# PERMIT

## SEWAGE DISPOSAL SYSTEM

SUBDIVISION Glenwood Estates LOT 1-SECT ROAD 14580 Mustang Path

REPAIR - PURPOSE - SEPTIC SYSTEM HAS FAILED.

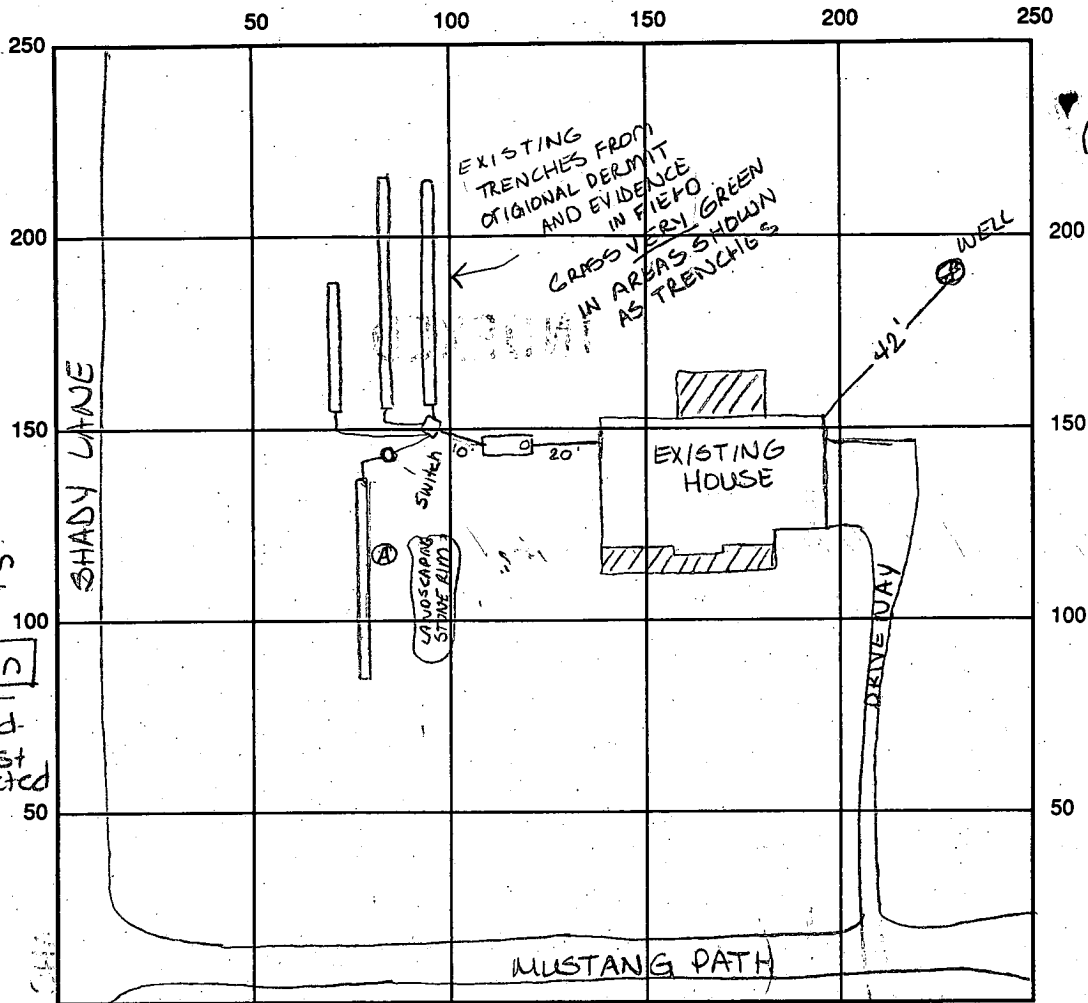
REMARKS: 4/6/95 No solution found, appears to be drainage from road which is causing failure. Aug 3/5/96 Drainage from surrounding properties, church and road is causing excessive drainage to septic location Aug/RB

12/3/96 Spoke to Kenny Hatfield - advised 125 per bdm OK to keep old sys w/ alternative switch. Would like to run another test to see if shallower perc is possible to put in greater depth of stone than 2.0' ALM

12/20/96 OK to put only 100' of trench. space extremely limited for repair OK to cover final - switch pot in ALM

3-7-96 Install trenches with maximum bottom depth of 8.5 feet, inlet at 6.5', with 2.0' of stone. Trenches to be 30' wide. Begin first trench approx. 105 feet up the left property line and 60 feet off that same lot line which facing property with Mustang Path. Recommend additional stone depth as upgrade to system but not a requirement. Amy McMillan

TITLE: GRADING STUDY				
PROJECT: GLENWOOD ESTATES - SECT. 1 - LOT 1				
LOCATION: 4TH ELECTION DISTRICT HOWARD CO., MD.				
SCALE: 1" = 50'	DESIGNED BY: JN	DRAWN BY: DP	CHECKED BY: JN	DATE: NOV., 1986
FIELD BOOK:	PAGE NO.:	JOB NO.: 80438	DRAWING NO.: 1 OF 1

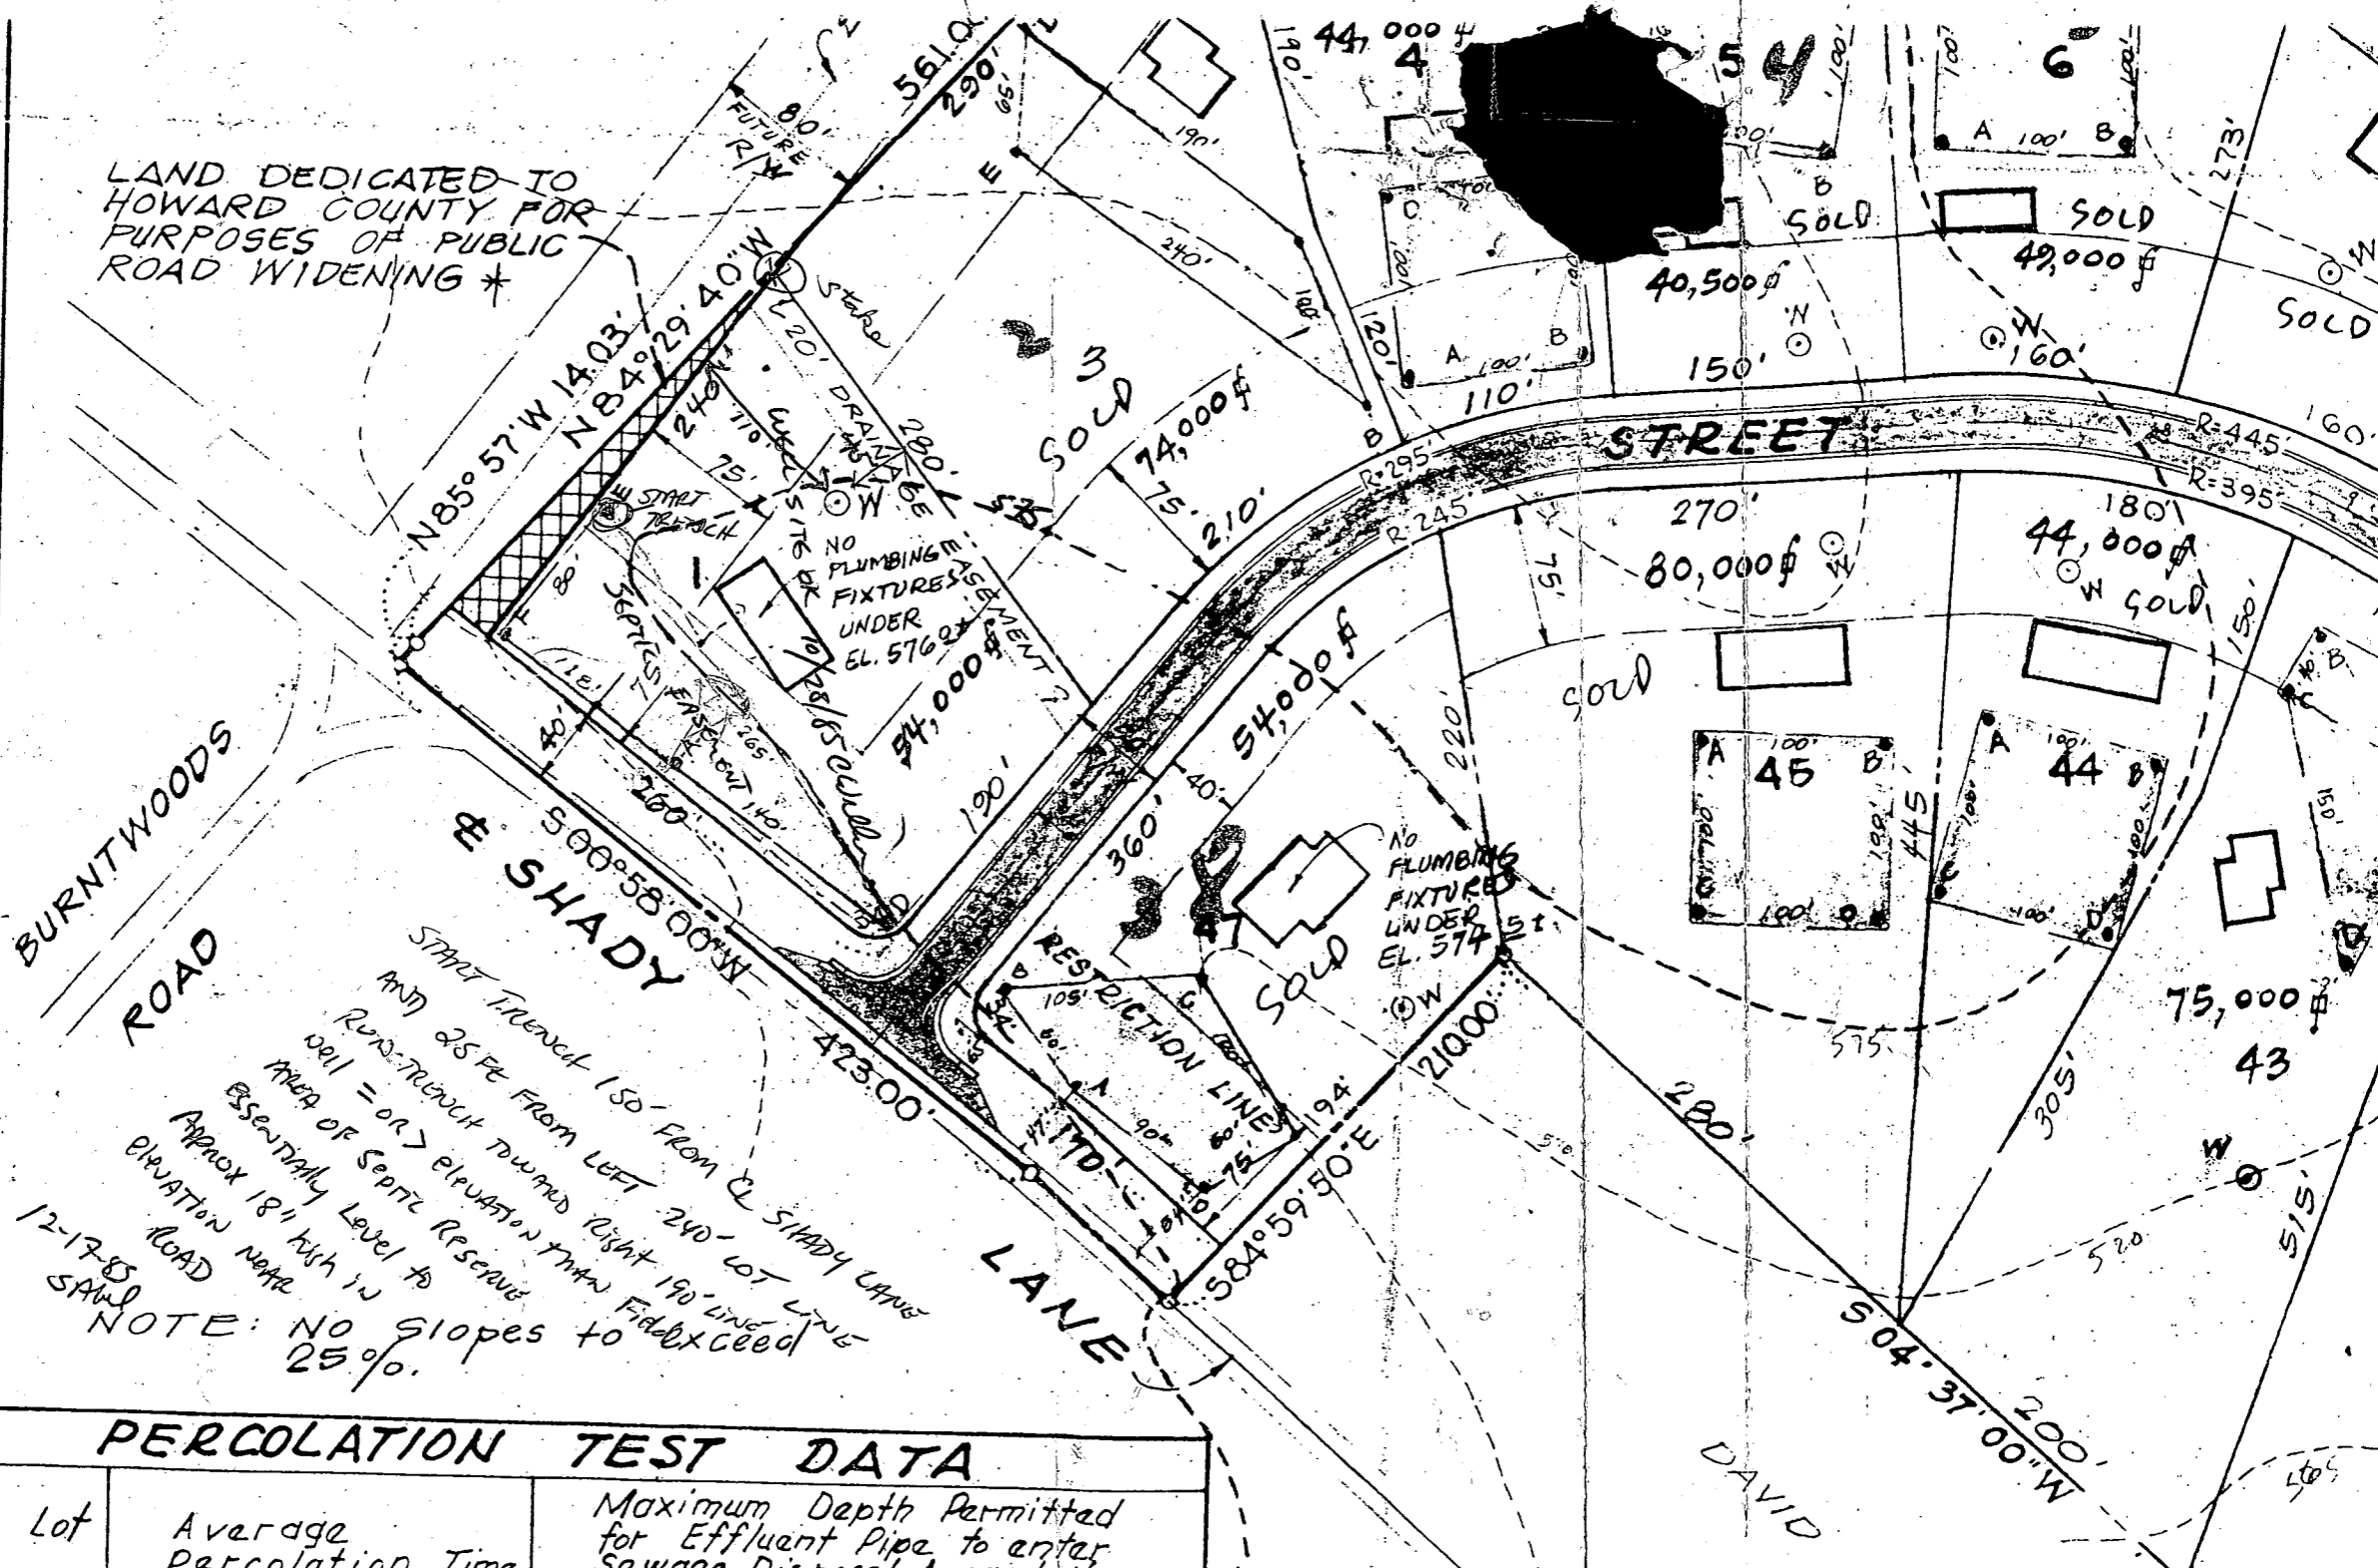
elevations ok  
11/26/86  
S. Abel

11/26/86  
Trenches shown  
sufficient for 600  
house.  
SAB

START TRENCH 150' FROM CL SHADY LANE AND 25 FT FROM LEFT 240' LOT LINE AND TRENCH TOWARD RIGHT 190' LINE AREA OF SEPTIC RESERVE ESSENTIALLY LEVEL TO APPROX 18" HIGH IN ROAD ELEVATION NOTE 12-17-85 S.W.D. NOTE: NO SLOPES TO EXCEED 25%.

TITLE <b>LOCATION SURVEY</b>				
PROJECT LOT 1 - GLENWOOD ESTATES - SEC. 1				
LOCATION 4TH ELECTION DISTRICT, HOWARD CO., MD				
FIELD BOOK —	PAGE NO. —	DRAWN BY: BH	CHECKED BY —	DATE: 1-16-87
SCALE: 1" = 50'		JOB NO.: 86433

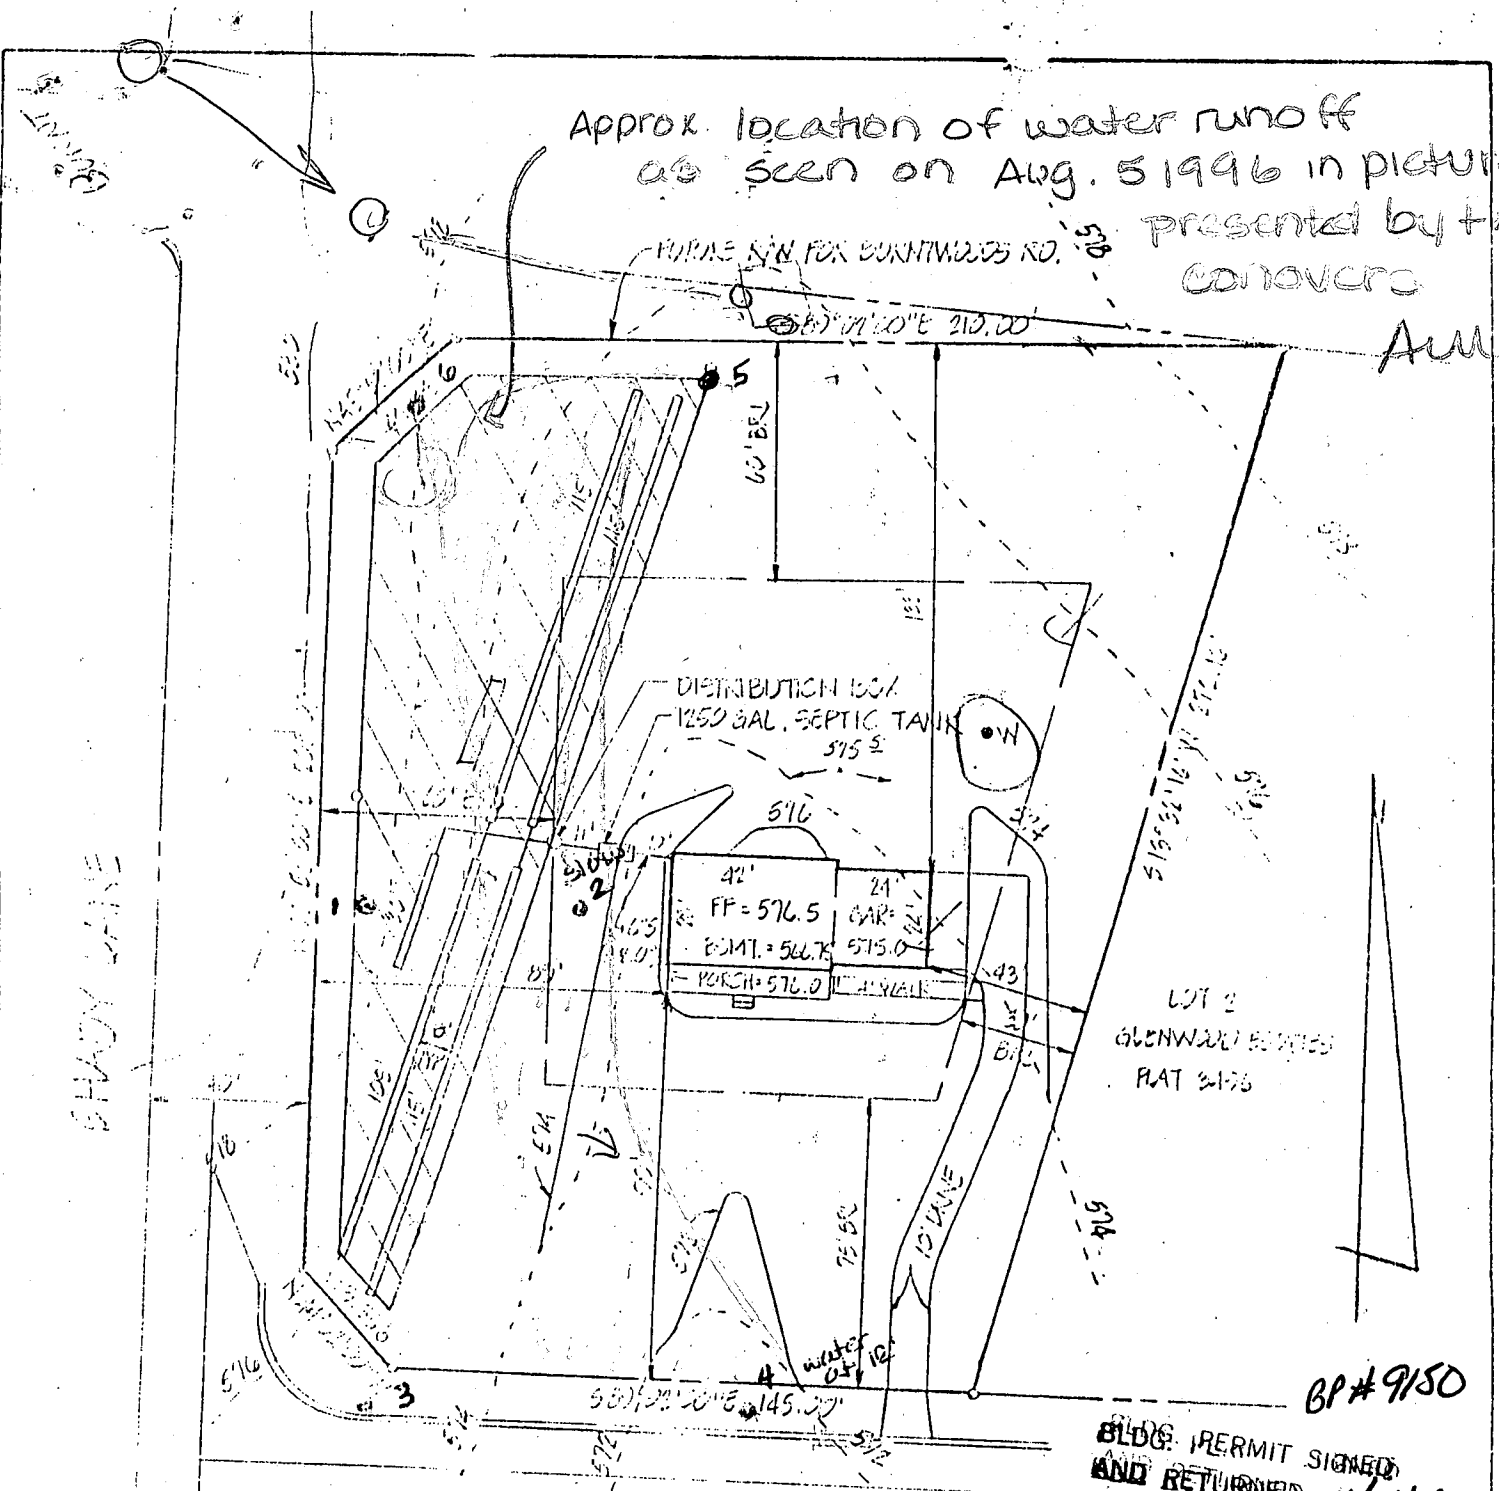
Approx. location of water runoff  
as seen on Aug. 5 1996 in pictures  
presented by the  
contractor
